TT253 – July 28, 2006

04-06 XL Rocker Box Gaskets

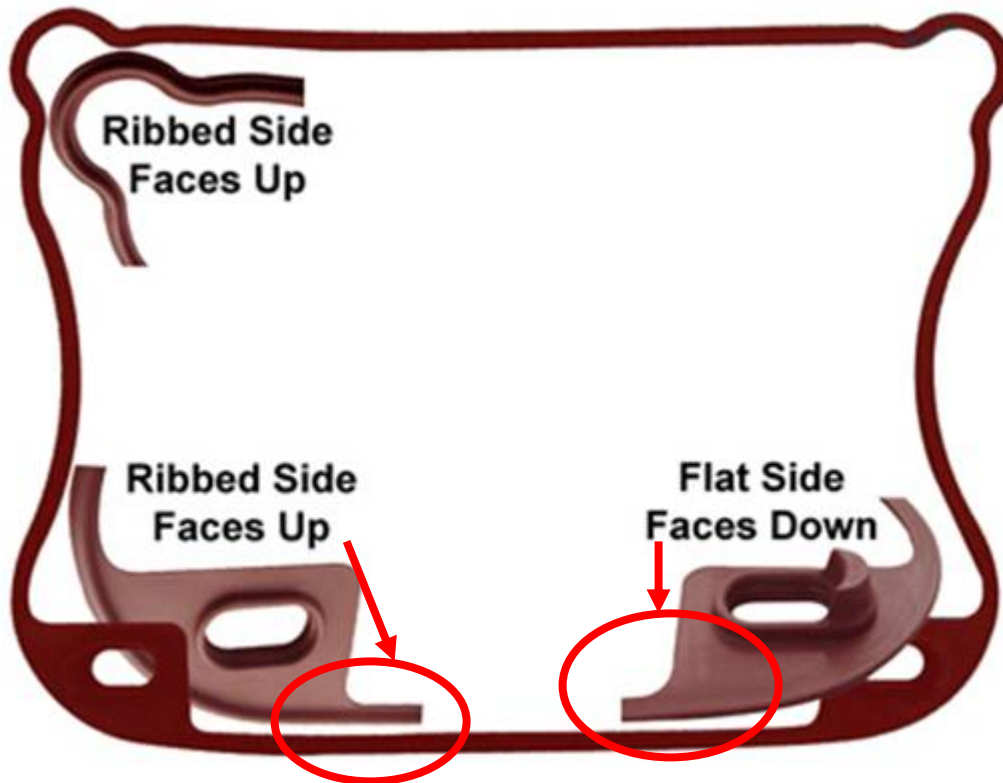
Recently we have developed and tested a new rocker box gasket with the help of the dealer network techs. & dealer staff. Thanks to your feedback it was very successful.

The gasket, which is brown in color, has a part number of 17353-89C. We prefer that the “C” version gasket is used only to make repairs on the 04-06 model year Sportsters at first to allow inventory and supply of the new gasket to stabilize.

The 17353-89B black colored gasket can still be used for 03 and earlier XL's with the 3 PC rocker box assy. The “B” version gasket works just fine for those years. Please use your existing inventory for these applications.
